**BEFORE THE NORTH CAROLINA UTILITIES COMMISSION
DOCKET NO. E-7, SUB 1214**

**Application of Duke Energy Carolinas,
LLC for Adjustment of Rates and
Charges Applicable to Electric Service
in North Carolina**

) **TESTIMONY OF PAUL J.
) ALVAREZ ON BEHALF OF THE
) NORTH CAROLINA JUSTICE
) CENTER, NORTH CAROLINA
) HOUSING COALITION, NATURAL
) RESOURCES DEFENSE COUNCIL,
) SOUTHERN ALLIANCE FOR
) CLEAN ENERGY AND THE
) NORTH CAROLINA
) SUSTAINABLE ENERGY
) ASSOCIATION**

Figure 1: Relationship Between Grid Investment and Reliability Without Major Events, U.S. IOUs

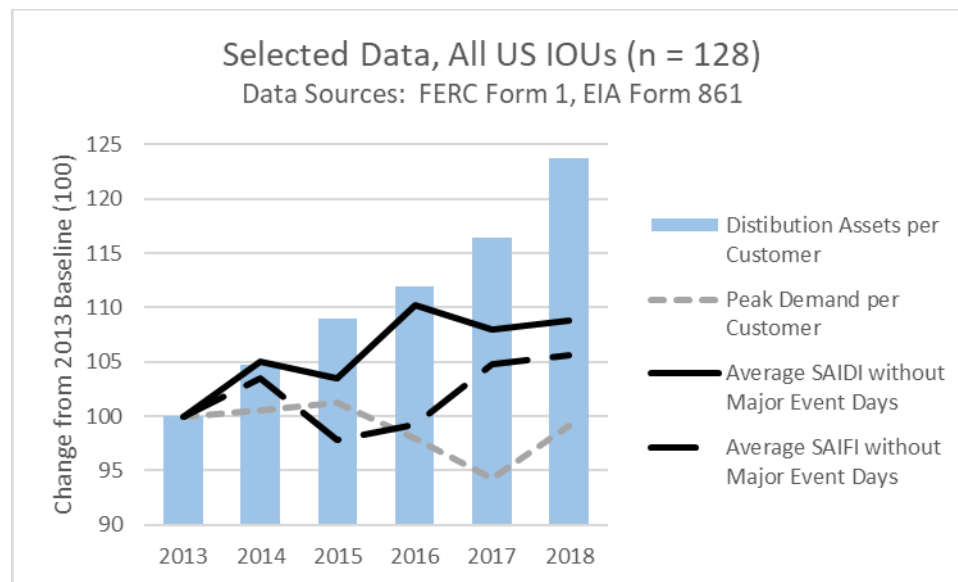
1 Figure 1 illustrates a counterintuitive caution to regulators: increased
 2 distribution investment is not correlated with reliability improvements. This
 3 conclusion is consistent with a Department of Energy study on U.S. electric
 4 reliability covering years 2002 to 2012.¹⁴ Figure 1 analyzes “clear day” reliability;
 5 that is, without major events.¹⁵ Figure 2, below, shows the same comparison, but
 6 using reliability measures that include major events. The relationship between
 7 distribution investment and improved resilience in the face of major events is even
 8 more tenuous than the relationship between distribution investment and clear-day
 9 reliability.
